Beaver Valley power Station, Unit No. 1  
Proposed Technical Specification Change No. 191

Beaver Valley Power Station, Unit No. 1  
Proposed Technical Specification Change No. 191  
Revision of technical Specification 3.4.9.1 and 3.4.9.3  
HEATUP AND COOLDOWN CURVES AND OPPS SETPOINT

The proposed amendment would extend the applicability of the heatup and cooldown curves to 16 effective full power years (EFPY) and modify the overpressure protection system (OPPS) pressure setpoint and enable temperature to incorporate analysis results applicable to 16 EFPY. In addition, Specification 3.4.1.6.1, Surveillance Requirement 4.4.1.6.1, and Bases 3/4.4.1 have been revised by changing "or" to "and."

FIGURE 3.4-2

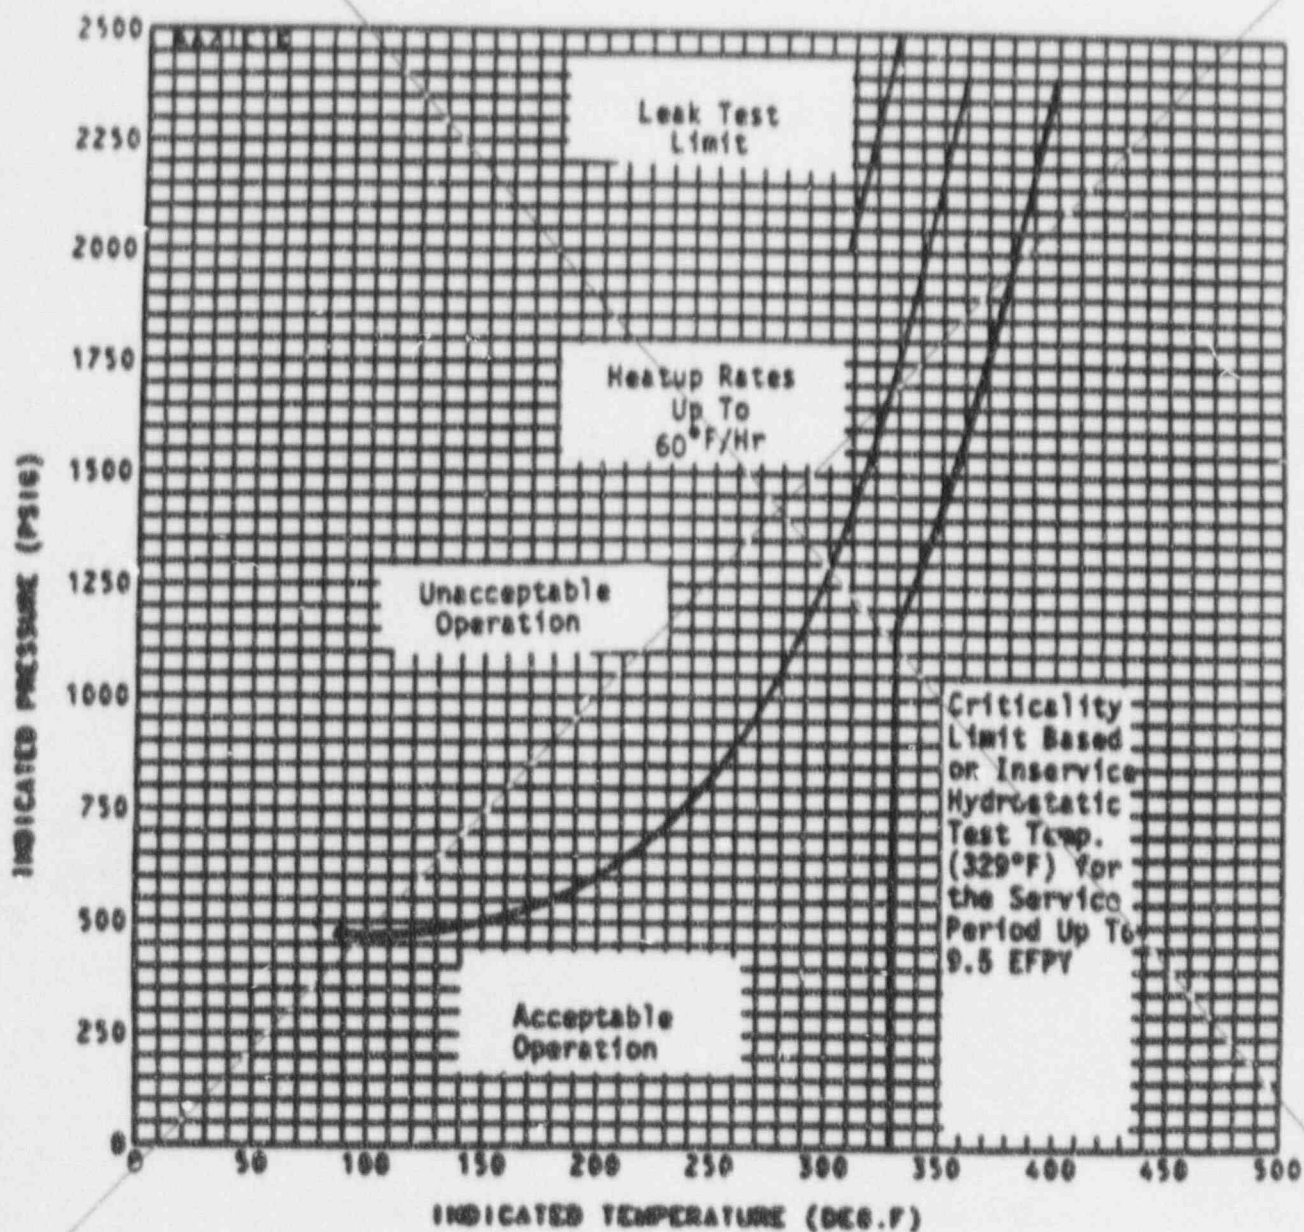
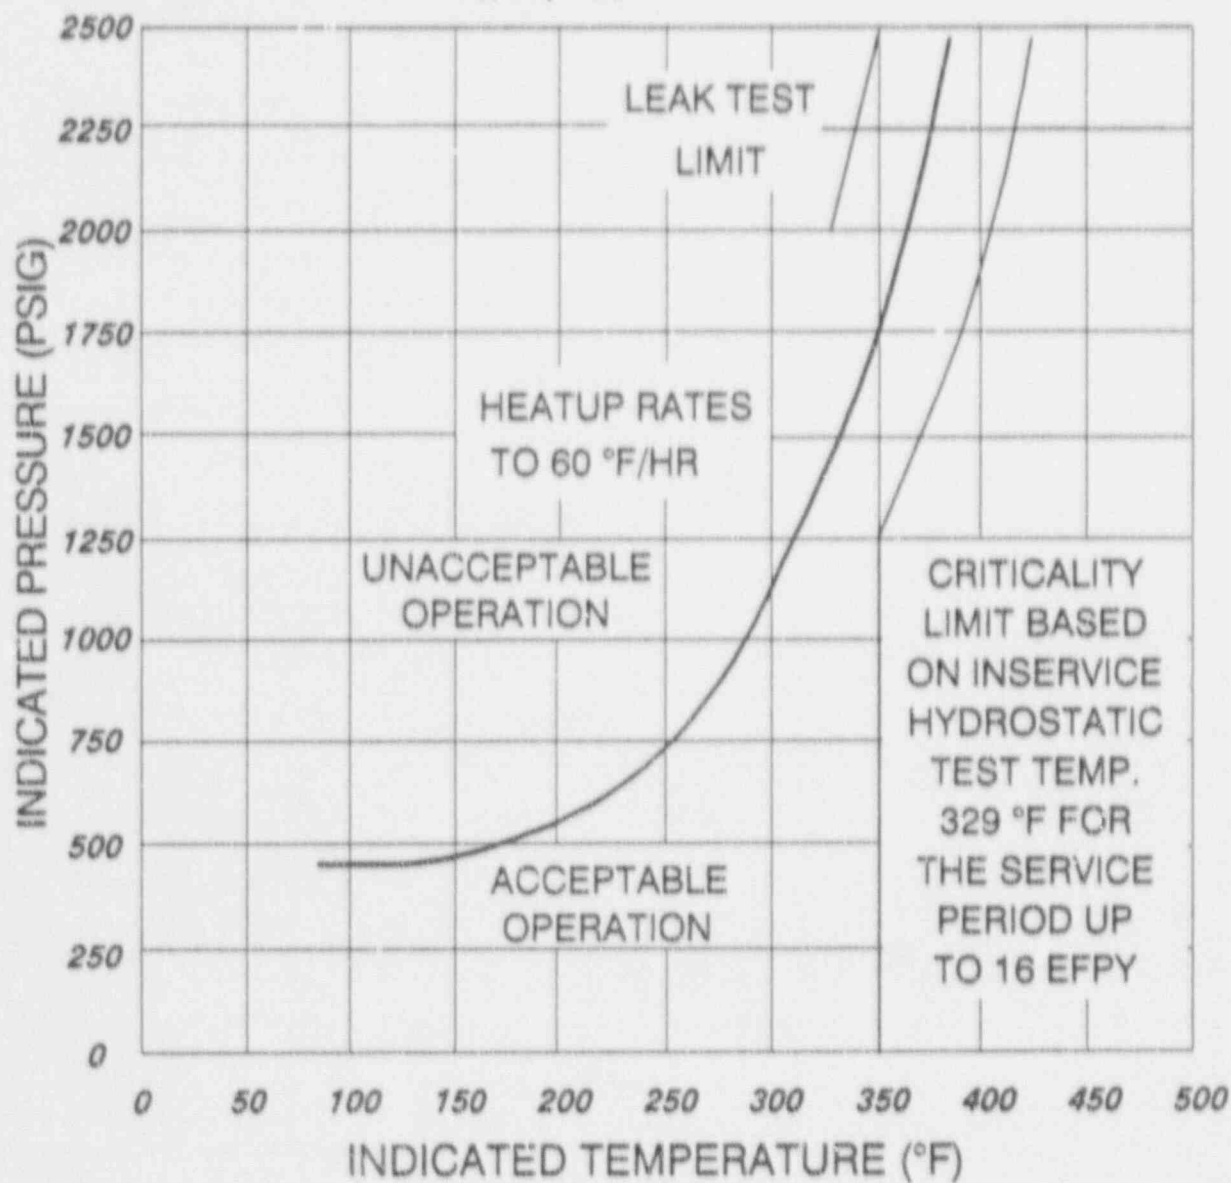
The proposed changes replace the current heatup and cooldown curves applicable to 9.5 EFPY, with curves applicable to 16 EFPY. The new curves were developed by Westinghouse in accordance with Attachment E, "Duquesne Light Company Beaver Valley Unit 1 Life Attainment Plan." The curves provided in this plan have been developed in accordance with Regulatory Guide 1.99, Revision 2.

The heatup and cooldown curves (Figures 3.4-2 and 3.4-3) have been updated to extend the applicable requirements to 16 EFPY. The curves applicable to 16 EFPY were developed in accordance with the same methodology used to develop the curves presently used. This will extend the applicability of these curves beyond the schedule for removal of the next surveillance capsule at 15 EFPY.

Beaver Valley Unit 1 Reactor Coolant System Heatup  
Limitations Applicable for the First 16 EFY
